DATE: June 7, 2019

SUBJECT: ADDENDUM #3 TO THE BIDDING DOCUMENTS FOR:  
**BID GROUP #6**  
**MASTER FACILITY PLAN IMPLEMENTATION**  
**COMMUNITY HIGH SCHOOL DISTRICT 99**  
**1436 NORFOLK STREET**  
**DOWNERS GROVE, IL 60516**

**BG6 BP2 Revised Concrete Scope**  
**BG6 BP3 Revised Precast Floor Plank Scope**

**MFP IMPLEMENTATION - SOUTH**

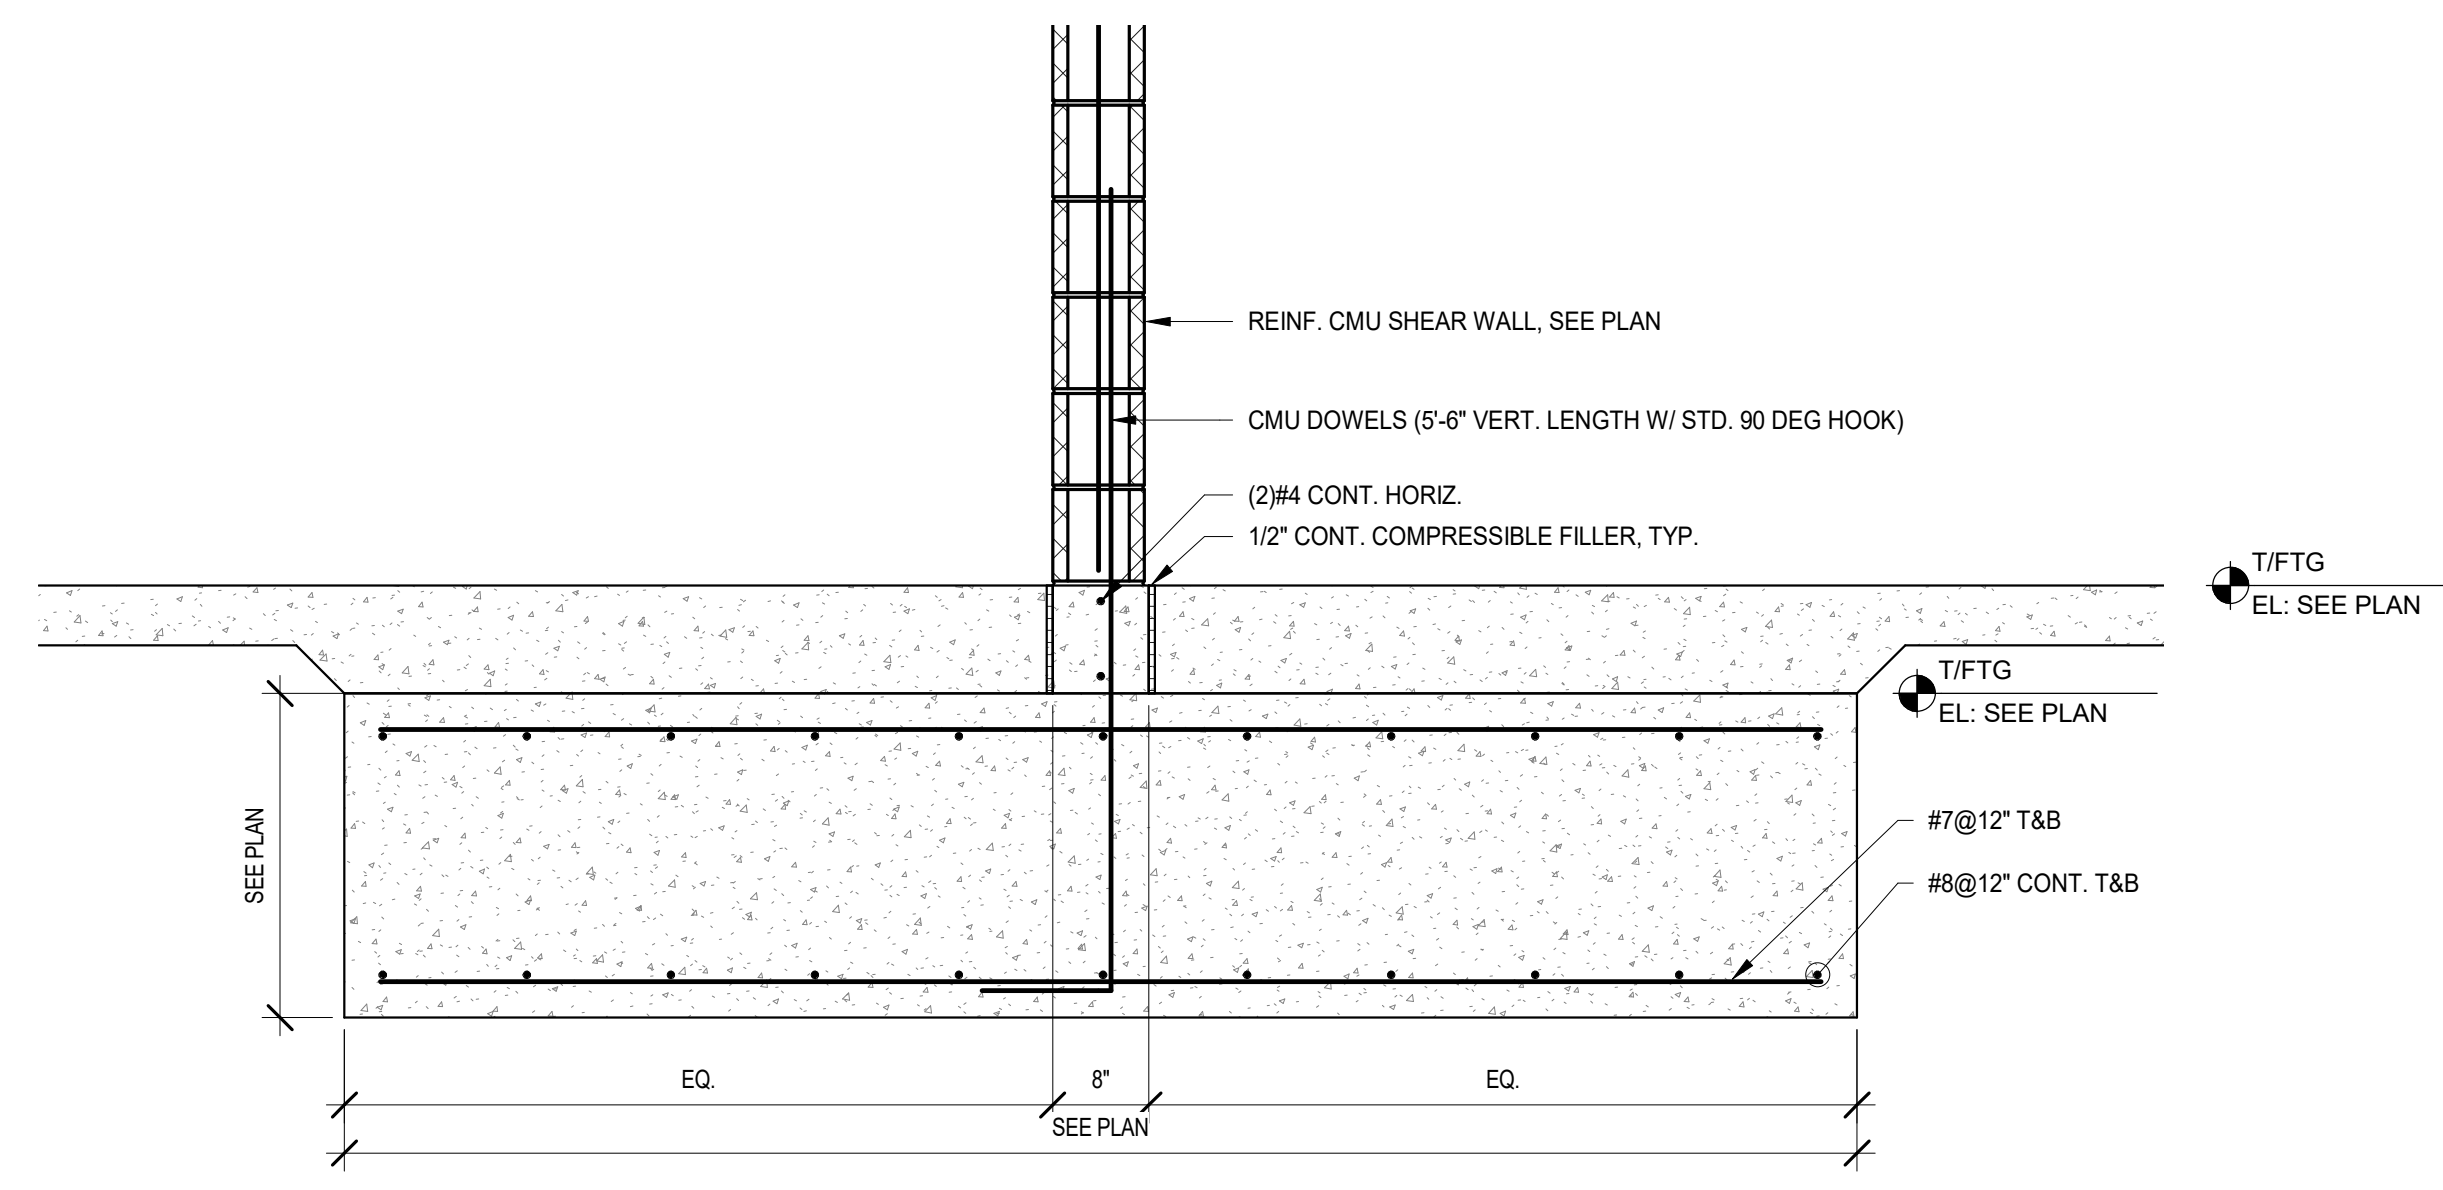
1. Sheet S2.2B-C1 2ND FLOOR FRAMING PLAN – AREA C.1 (**Full size sheet reissued**):
  - a. Slab edge detail along C.D, C.E, C.F AND C.G modified.
2. Sheet S3.2B NON-TYPICAL SECTIONS AND DETAILS (**Full size sheet reissued**):
  - a. Continuous embed plate added to detail 10.
